# 2020 Corvette: GM TechLink: Removal of Corvette Z51 Spoiler

## Removal of Corvette Z51 Spoiler

**June 29, 2020**  
**GM TechLink**

**Fig. 15**

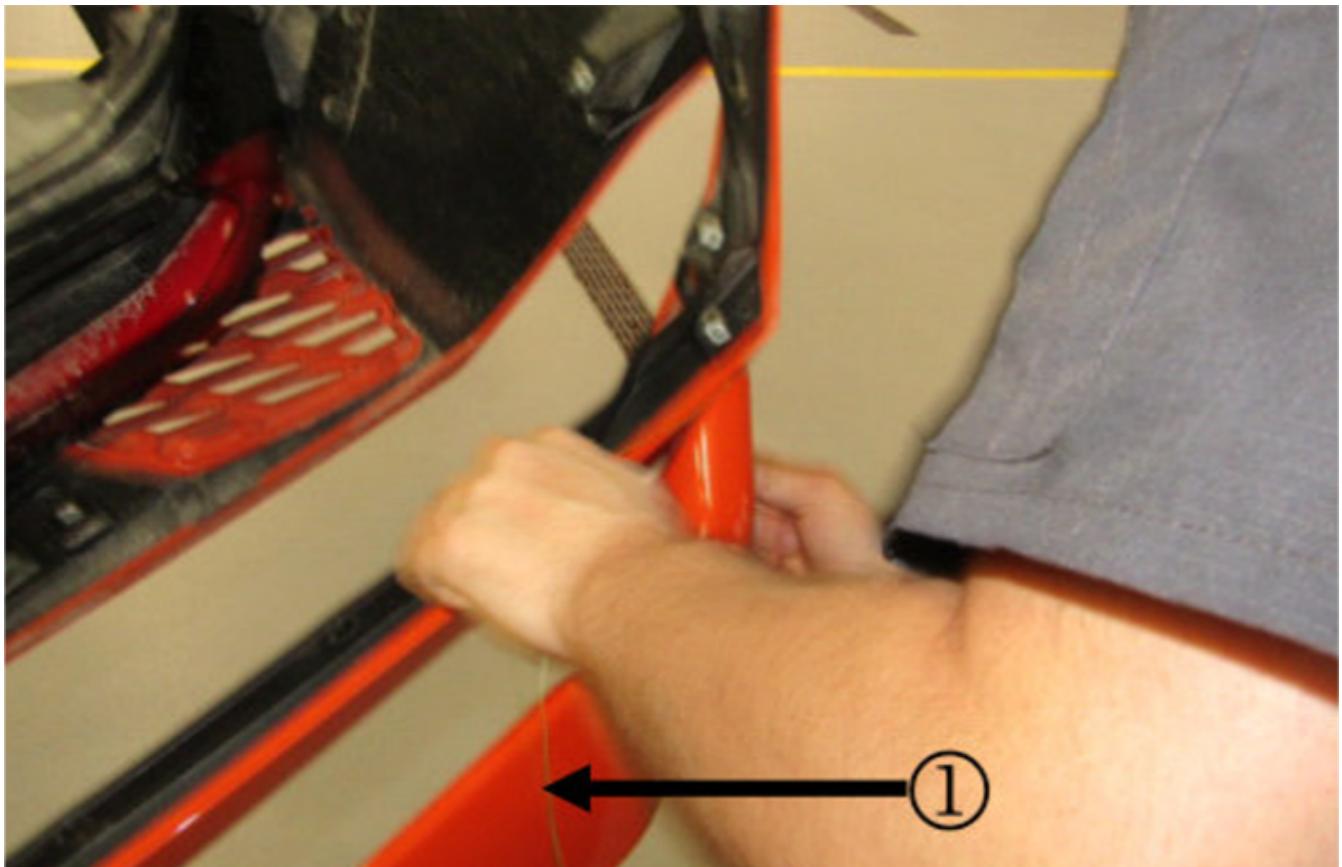
2020 Corvette Stingray models equipped with the Z51 Performance Package feature a rear spoiler that adds downforce to improve high-speed stability. (Fig. 15) If the Z51 spoiler is to be replaced with the high wing accessory spoiler, there may be some concern about applying heat to soften the two-way tape retaining the spoiler without damaging the rear fascia paint. The fascia paint may not be able to withstand high heat generated by a heat gun.

**Fig. 16**

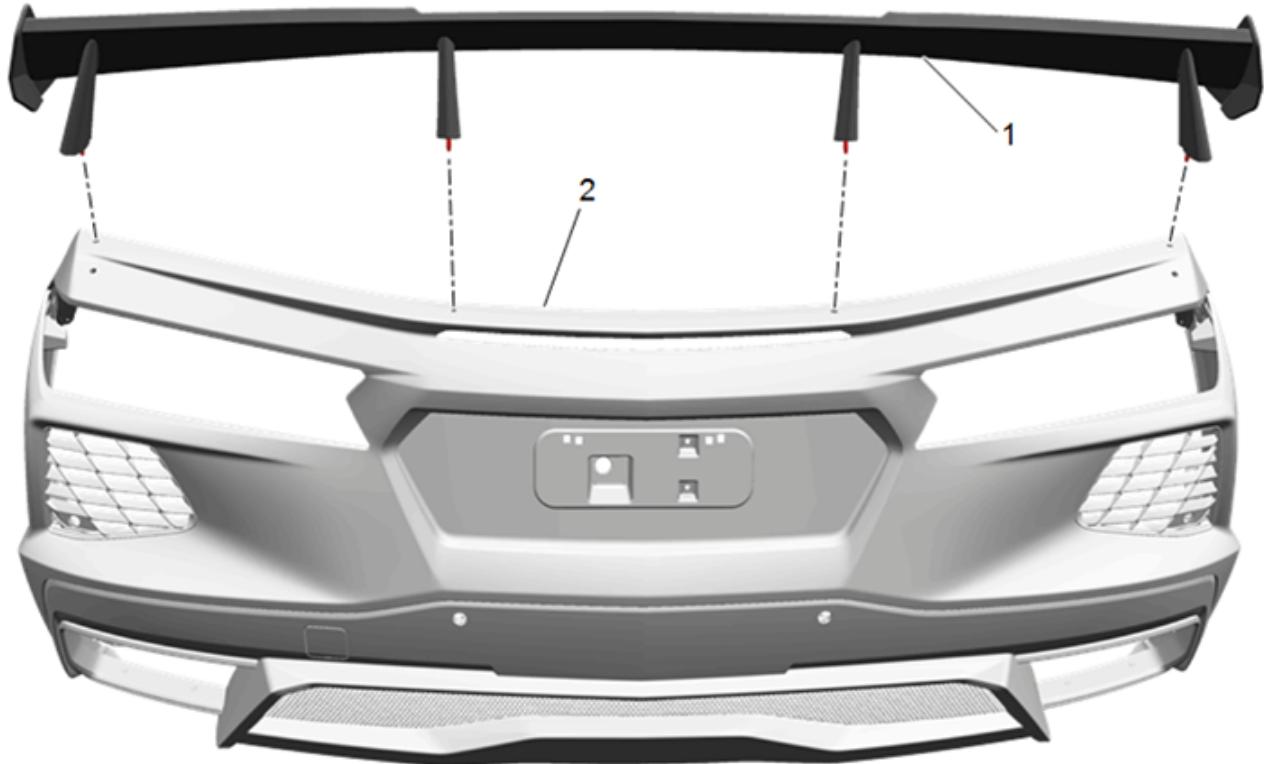
To remove the Z51 rear spoiler, it's recommended to use 50 lb. test monofilament fishing line. Position the line (Fig. 16, #1) between the spoiler and fascia and, with a sawing motion, move the fishing line through the two-way tape to remove the spoiler. Using the fishing line method will eliminate any possibility of damage to the painted fascia surface.

Do not use a heat gun, or attempt to pry the spoiler off the fascia with a plastic, metal or wood trim removal tool, in order to loosen the adhesive tape.

The installation instructions for Rear End Spoiler Package Installation (Fig. 17) in the Accessories Manual in the Service Information have been updated to eliminate the use of a heat gun to soften the two-way tape. Follow the updated installation instructions and do not use a heat gun during the removal process.
